Item TE31.8: 1233 Yonge Street and 9 Woodlawn Avenue East

TE31.8: 1233 Yonge Street and 9 Woodlawn Avenue East
Official Plan and Zoning By-Law Amendment Application

2024 Avenue Segment Study

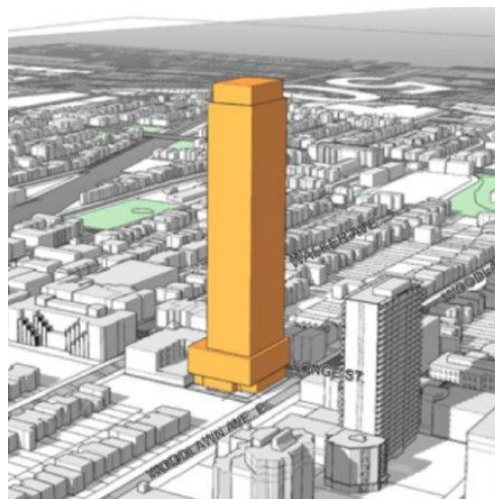
The applicant's *Avenue Segment Study* illustrates the future development of ten soft sites between Farnham and Birch with an average density of FSI 9.9 and an average height of 24.9 floors. The urban design consultant, evidently, recognized that it would be absurd to intensify the remaining soft sites with comparable locational characteristics in similar form, scale and intensity with a density of FSI 24.0 and a height of 47 floors, as called for by the Official Plan. Hence, the applicant's own study demonstrates that a density of FSI 10.0 and a height of 25 floors may, perhaps, represent a reasonable planning proposition

Mixed Use Area 'C'

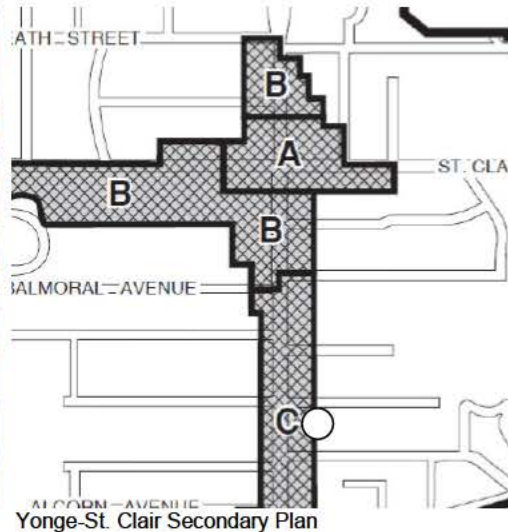
The applicant continues to maintain that planned towers in Mixed-Use Areas A and B are valid precedents, ignoring the materially different land use context, with 1233 Yonge in Mixed Use Area 'C', dwarfing the adjacent low-scale Neighbourhoods to the east and west, as opposed to relating to towers in Apartment Neighbourhoods.

Harmonious Street Context?

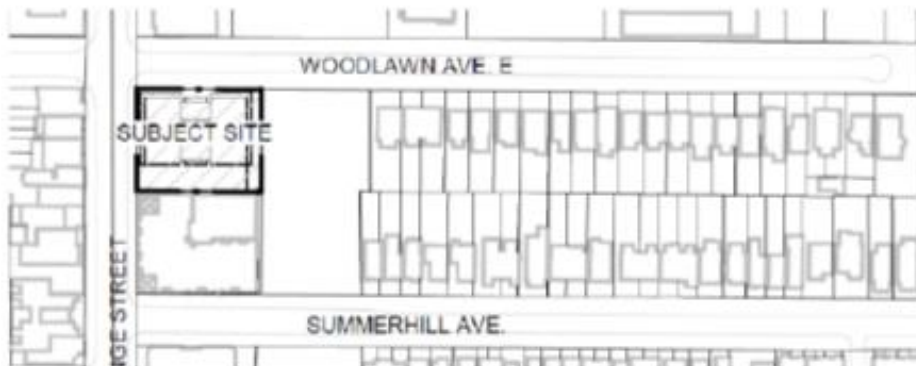
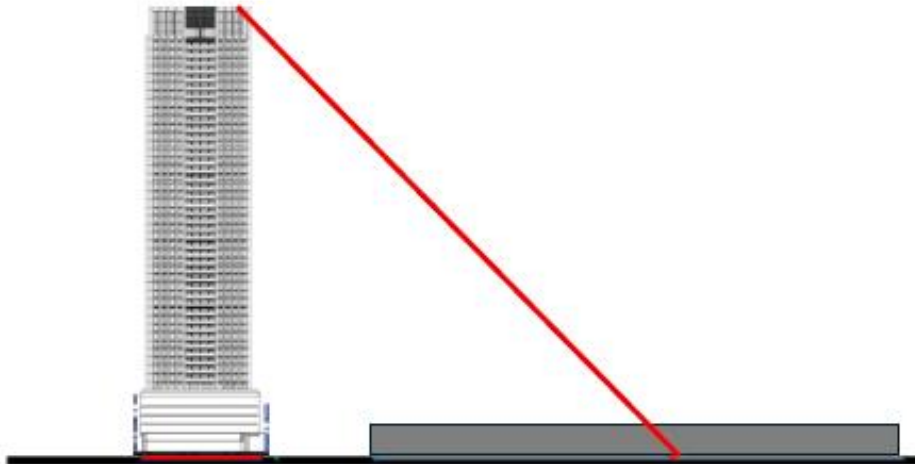
OP Policy 4.5.2 (Mixed Use Areas): “In Mixed Use Areas development will: ... c) locate and mass new buildings to provide a transition between areas of different development intensity and scale, as necessary to achieve the objectives of this Plan, through means such as providing appropriate setbacks and/or a stepping down of heights, particularly towards lower scale Neighbourhoods; d) locate and mass new buildings so as to adequately limit shadow impacts on adjacent Neighbourhoods, particularly during the spring and fall equinoxes....”

45 ° Angular Plane between Tower and low-scale Neighbourhood

Precedents adjacent to Apartment Neighbourhoods? City-initiated Planning Framework: Height Peak Areas

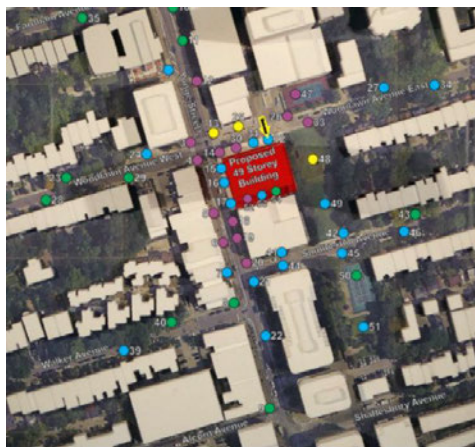
Planning Framework Policy 2 (Goals): “The Goals of the Planning Framework are to: iii) Appropriately transition tall building heights from a Height Peak around the Yonge St. Clair intersection downward to lower-scaled areas.”

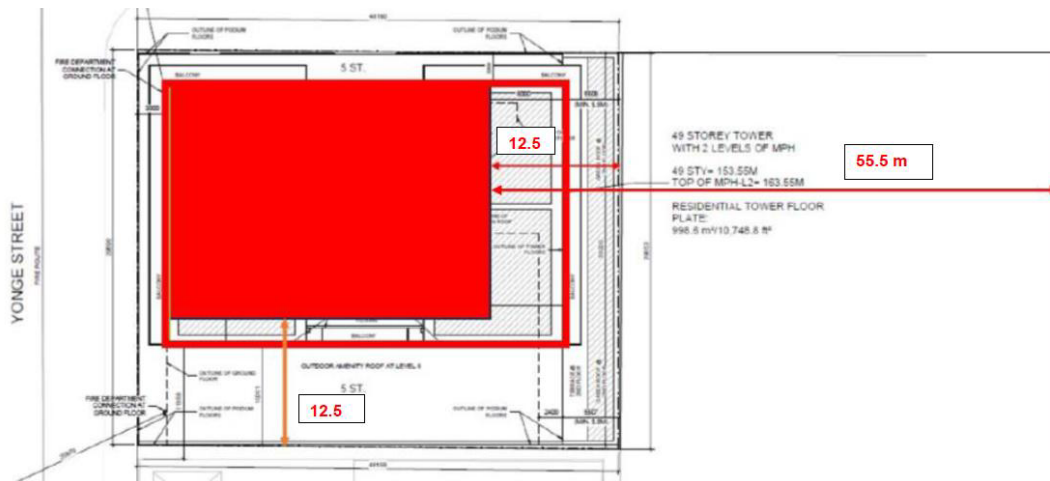
The proposed tower floor plate is 1,007 m² or 34% greater than the maximum of 750 m² recommended by the TBDG on a tiny site of 0.19 ha. Both the Official Plan and TBDG call for the transition in scale to be accommodated on the development site itself. Increasing the minimum tower setback on the east from 6.0 m to the recommended minimum of 12.5 m and the tower setback to the south from the proposed 10.0 m to the recommended minimum of 12.5 m would reduce the floor plate from the proposed 1,007 m² to a more reasonable 750 m², as called for by the TBDG.
